ACCESSION NBR: 9311160297 DOC. DATE: 93/11/11 NOTARIZED: NO DOCKET #  
FACIL: 50-305 Kewaunee Nuclear Power Plant, Wisconsin Public Service 05000305  
AUTH. NAME: STEINHARDT, C.R. AUTHOR AFFILIATION: Wisconsin Public Service Corp.  
RECIP. NAME: Document Control Branch (Document Control Desk)

SUBJECT: Responds to 881123 GL 88-20, Individual Plant Exam For Severe Accident Vulnerabilities.

Docket 50-305  
Operating License DPR-43  
Kewaunee Nuclear Power Plant  
Response to Generic Letter 88-20, Individual Plant Examination

Figure 1. Flexible wedge gate valve

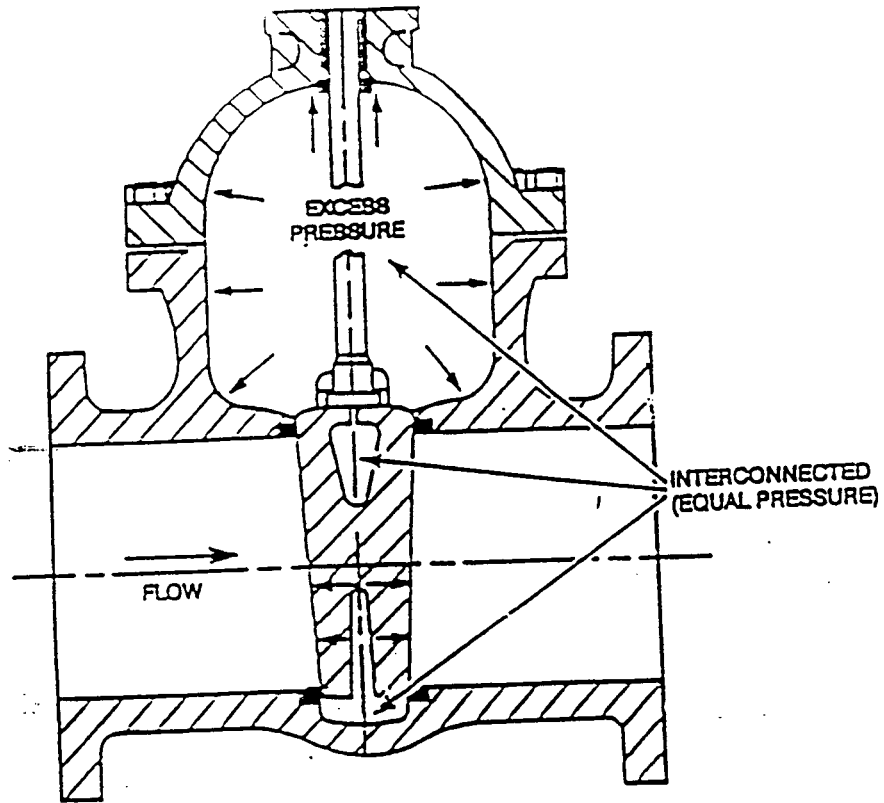
Since then, the NRC issued NUREG-1275, Vol. 9 (reference 5), which states that certain valves are susceptible to pressure locking and thermal binding. The valves mentioned above, designated SI-302A and SI-302B in the plant, are among the valves that WPSC engineering staff has determined may be subject to this phenomenon.

Each of these valves are isolated from the reactor coolant system (RCS) by two check valves. Leakage past these valves would cause the line downstream of SI-302A or SI-302B to pressurize to near RCS pressure (2235 psig), while the upstream side would stay at near atmospheric pressure. This large differential pressure could cause the valve disc to move slightly off its seat, allowing high pressure fluid to enter the valve bonnet. This would cause the bonnet to pressurize as well, as shown in Figure 1 of Attachment 1. If a large break loss of coolant accident (LOCA) were then to occur, the fluid on the downstream side would rapidly depressurize, causing the high pressure fluid in the bonnet to press tightly against both seats, as shown in Figure 2 of Attachment 1. When the valve receives a signal to open as part of the automatic SI signal in response to the LOCA, the valve operator may not be capable of producing enough thrust to dislodge the discs from both seats. Because a LOCA would have the same effect on both lines, this is a potential common mode failure, resulting in the inability to get low pressure SI flow into the reactor vessel.

In conclusion, WPSC has determined that valves SI-302A and SI-302B should remain normally open because of the possibility of pressure locking in the event of a large break LOCA. Therefore, the commitment to close SI-302A and SI-302B during normal power operations is hereby rescinded. If there are any questions regarding this letter, please contact a member of my staff.

Figure 2. Pressure Locking resulting from a LOCA

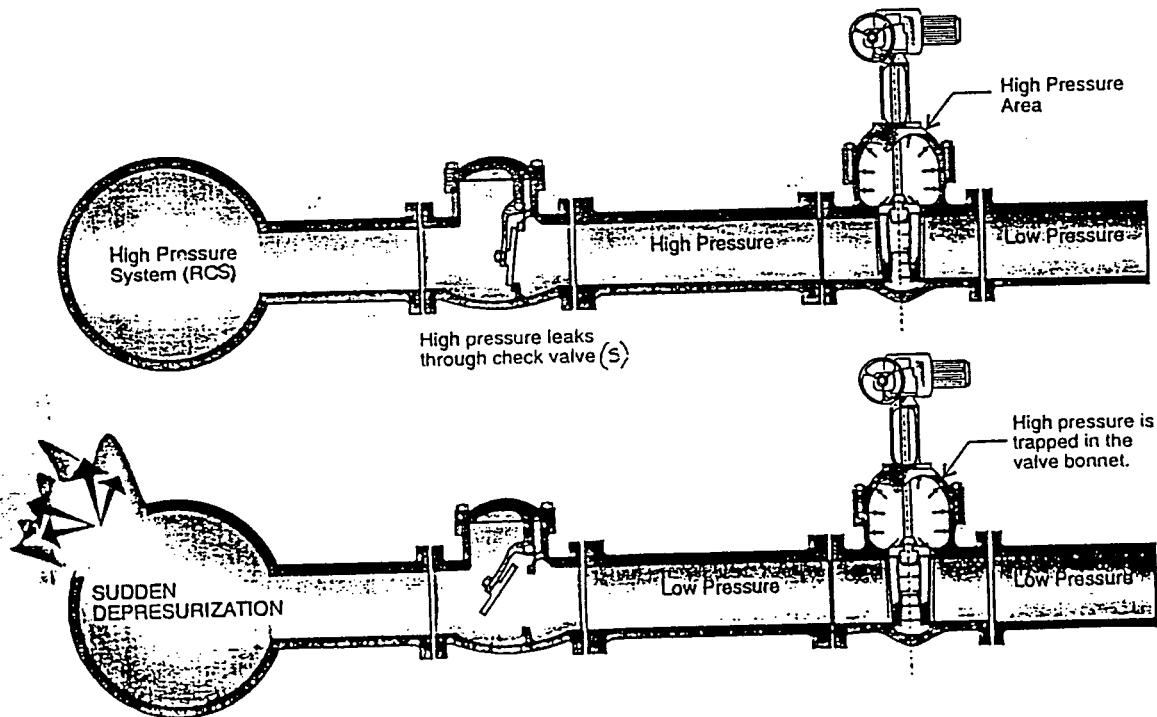
Therefore, WPSC has decided that the normal position of the valves should remain as open. Since the Kewaunee IPE assumed that the valves were closed during normal operations, it was necessary to make a change in the IPE. There are two competing effects of this change. First, the overall core melt frequency decreases by  $2E-6$  due to the fact that SI-302A and SI-302B do not have to open in the event of a LOCA. Second, the frequency of containment bypass increases by  $2E-8$ , due to fact that SI-302A and SI-302B are open and therefore must be closed manually to mitigate an interfacing system LOCA (ISL).

**FIGURE 3**  
**INTERFACING SYSTEMS LOCA EVENT TREE**

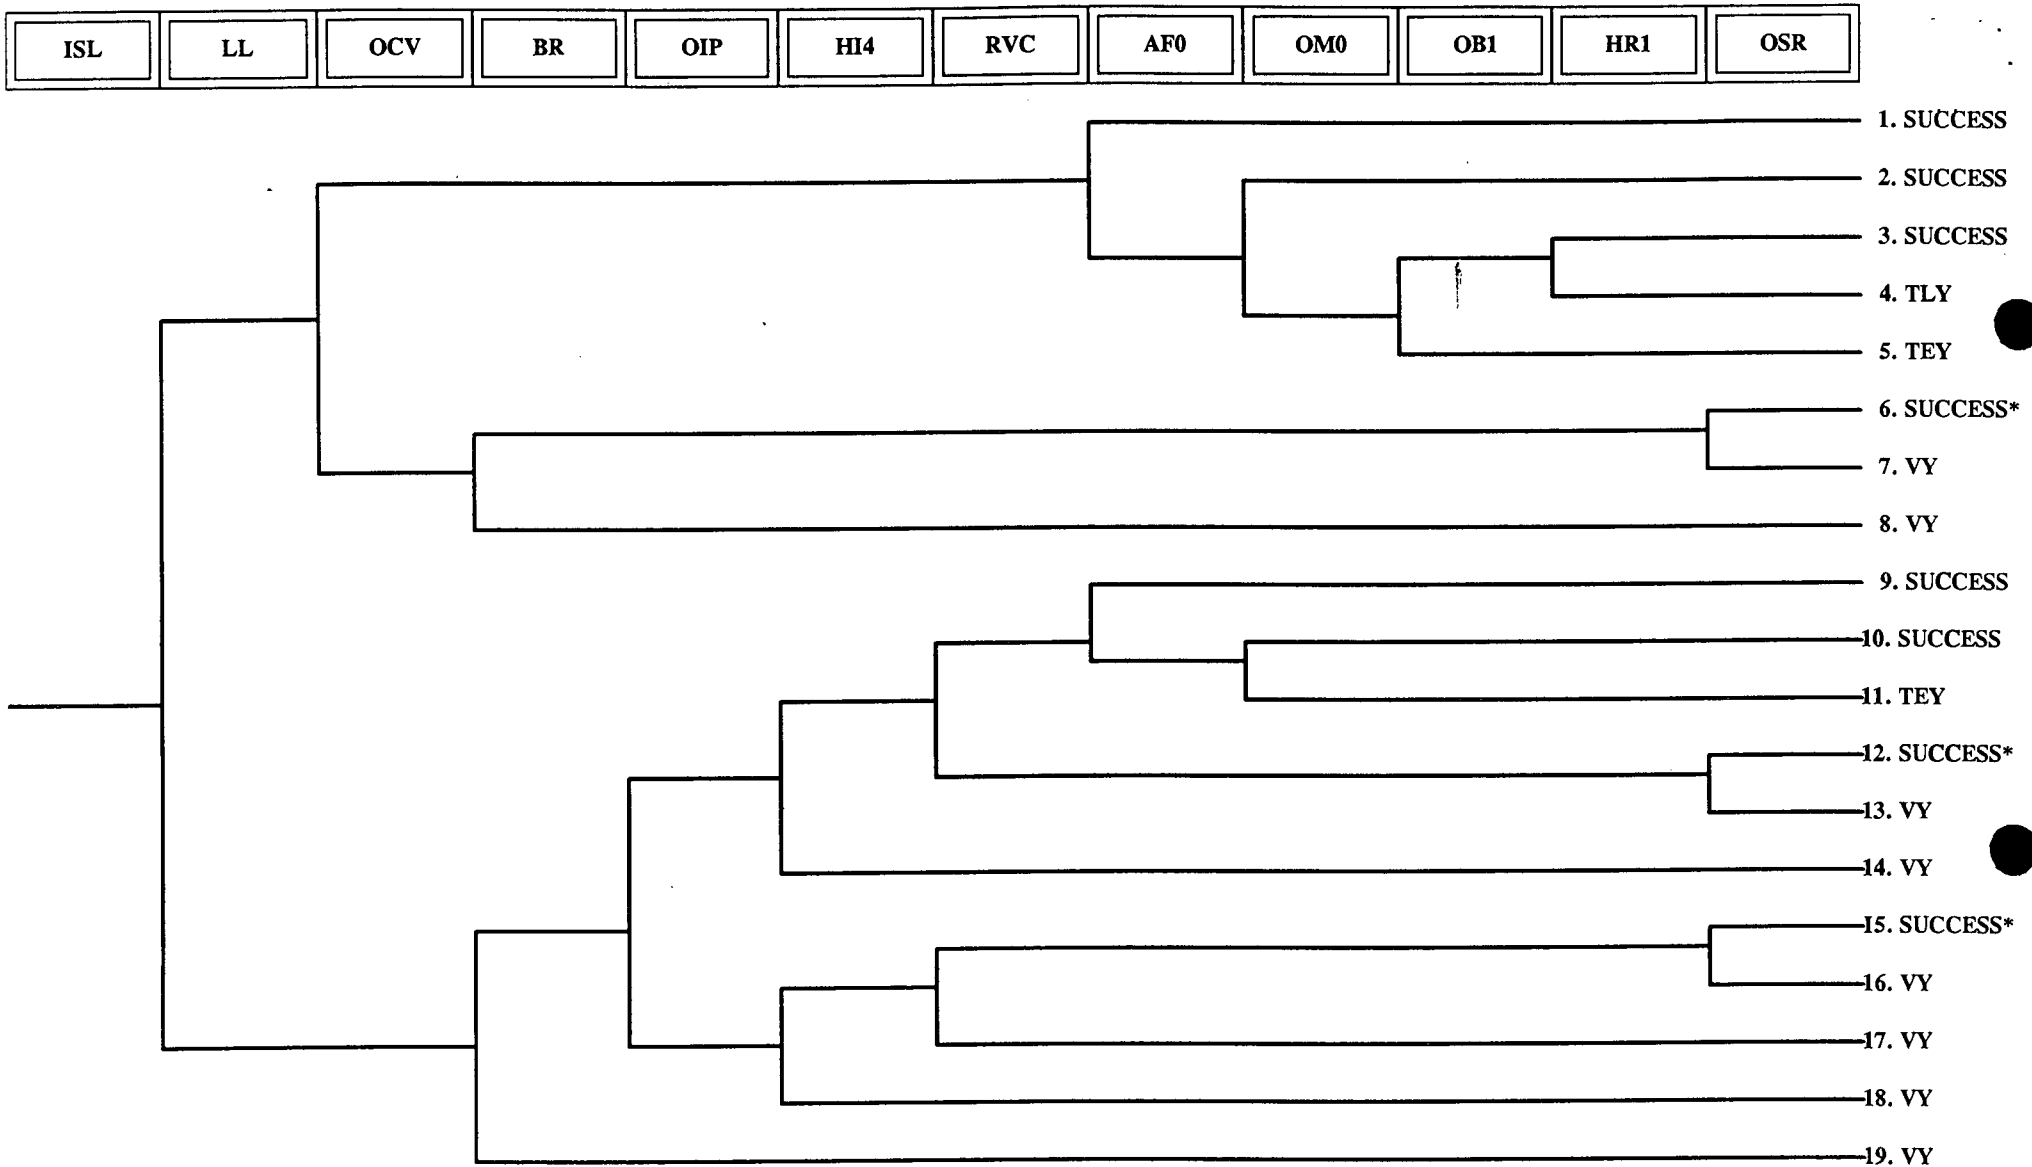
Table 1 shows the revised total core melt results (Table 3.4.4-1 in the original submittal). Only the small LOCA, medium LOCA, large LOCA and interfacing system LOCA events are affected by the change. Table 2 shows the sequences that changed, i.e., changes to Table 3.4.4-4 of the original submittal. Note that four new ISL sequences appear, only two of which are non-zero. Figure 3 shows the revised event tree for the ISL and Table 3 describes the four new top events. In this revised event tree, operator actions are necessary to isolate an ISL due to leakage of the check valves down stream of SI-302A or SI-302B. This operator action is proceduralized in the Emergency Operating Procedures.

The new ISL sequences are bounded by the steam generator tube rupture (SGR) event. This can be done because no credit is taken in the SGR for fission product scrubbing by the secondary water in the steam generator, i.e. it is assumed to be dry. The ISL is in reality less severe than the SGR because of fission product retention in the auxiliary building. Since the ISL frequency is two orders of magnitude less than the SGR frequency, this conservatism is of little consequence.
